Agenda Date:	June 27, 2019	Application ID:	SP 2019-06
Project:	Diversified Aviation Phase IIA	Project Number:	PRJ 2019-08
Project Planner:	Joseph Yaciuk, Planning Administrator		
Owner:	Cary Goldberg	Agent:	Barranco Gonzalez Architecture
Location:	North of Pembroke Road and west of Southwest 72 Avenue		
Existing Zoning:	A-1 (Limited Agricultural)* (Existing Airport)	Existing Land Use:	Transportation
Reference Applications:	SP 2011-18, ZV 2011-50, SP 2012-12, SP 2014-23		
Applicant Request:	Amending a previous site plan to allow for the construction of two new Hangars to replace three previously approved and unbuilt hangars.		
Staff Recommendation:	Approval, subject to the applicant providing LED lighting fixtures that do not exceed 3000k Correlated Color Temperature (CCT) in compliance with City of Pembroke Pines lighting code.		
Final:	<input checked="" type="checkbox"/> Planning & Zoning Board	<input type="checkbox"/> City Commission

Re: SP 2019-06 (Diversified Aviation)

PROJECT NAME: Diversified Aviation at NPA – Ph. IIA

PROJECT NAME: **Diversified Aviation at North Perry Airport –Phase IIA;**
SP2019-06

B6 CODE ANALYSIS

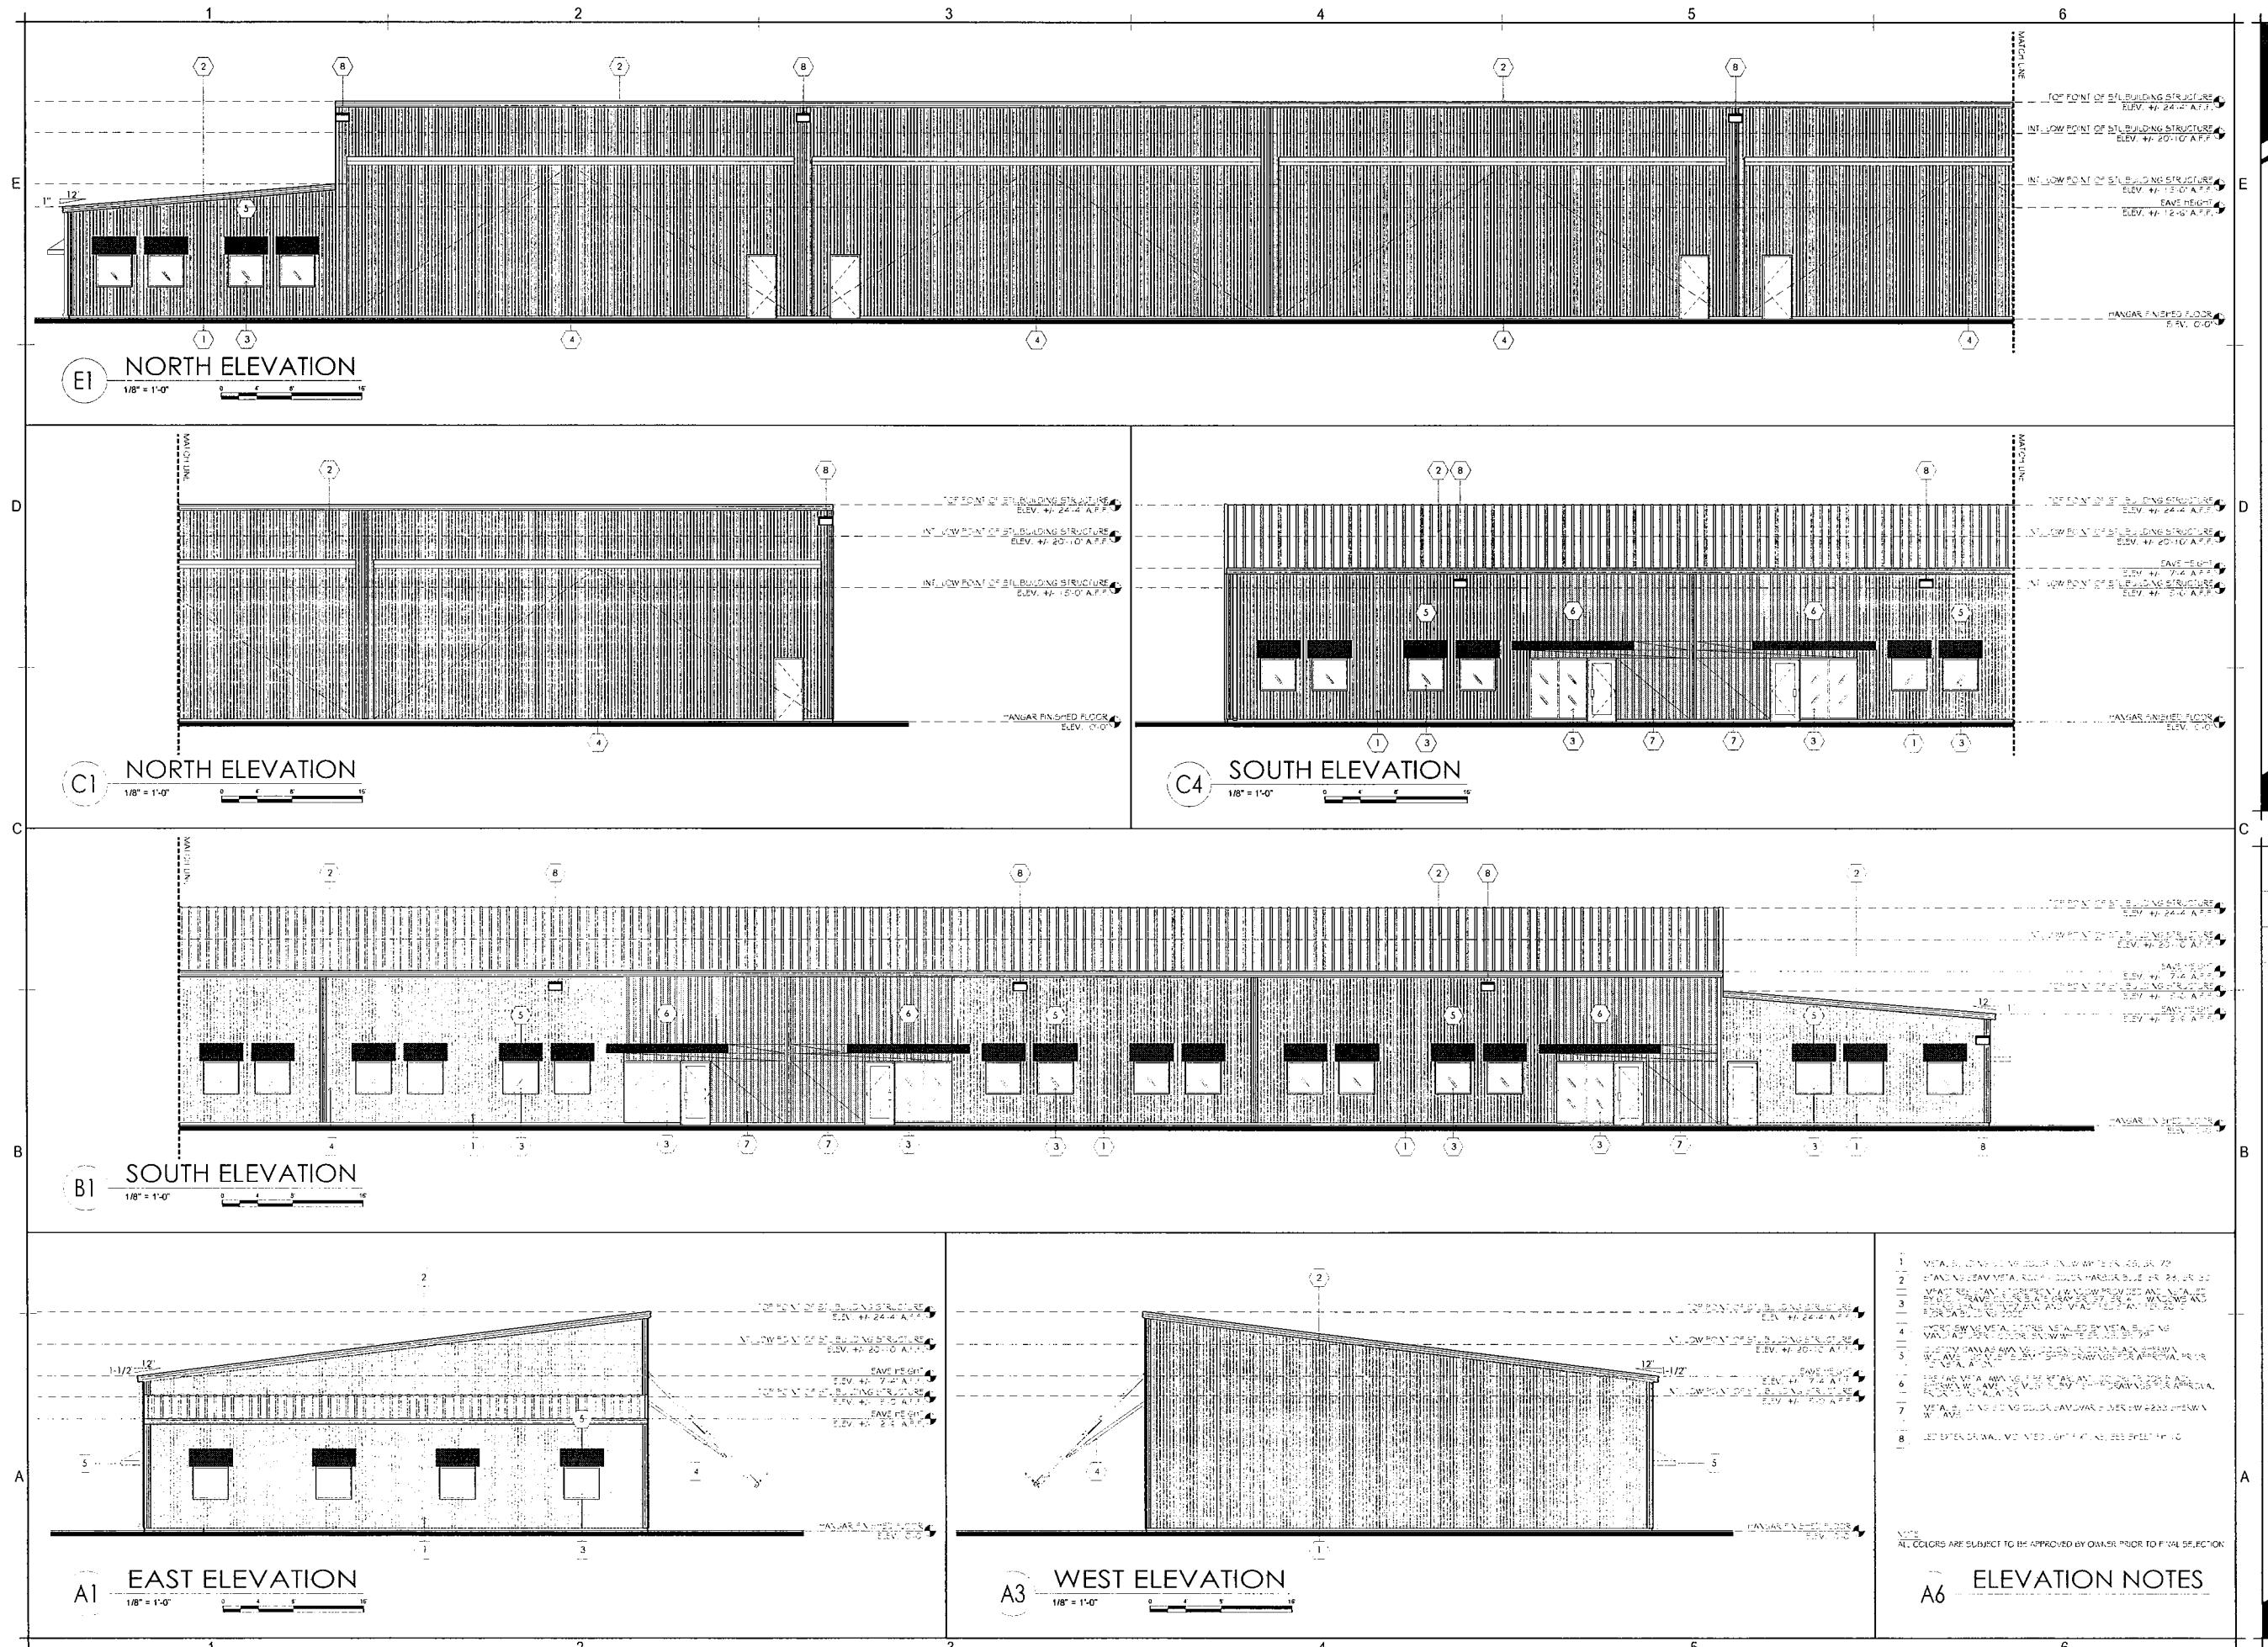
1. Has this revision been reviewed by BCAD? Provide BCAD's comments.
2. On page A101 show Fire Codes in effect: Florida Fire Prevention Code (FFPC) 6th edition with Broward County Amendments, which includes NFPA 101, 2015 edition, NFPA 1, 2015 edition, & State Statutes, 2018 edition. NFPA 409, 2011 edition, FBC 6th edition. (Adopted referenced publications found herein.)

3. Insufficient building data information provided on plans. On sheet A101, please declare Aircraft Hanger Classification Group Type and Construction Type on Plans. (NFPA 409: Chapter 4 and 5, 2011 Edition).

4. Declare on sheet A101 of strictly storage or will there be servicing of aircrafts as well.
5. Show fire hydrant placement on sheet A101.
6. Fire hydrant show on the north side of building 6 appears to be on the airside of the building; if so, provide detail of height clearance for aircraft wing span.

8. Dead end fire department access roads in excess of 150 feet in length shall be provided with approved provision for the fire apparatus to turn around. See the north side of building 6. Please address. NFPA 1: 18.2.3.4.4.
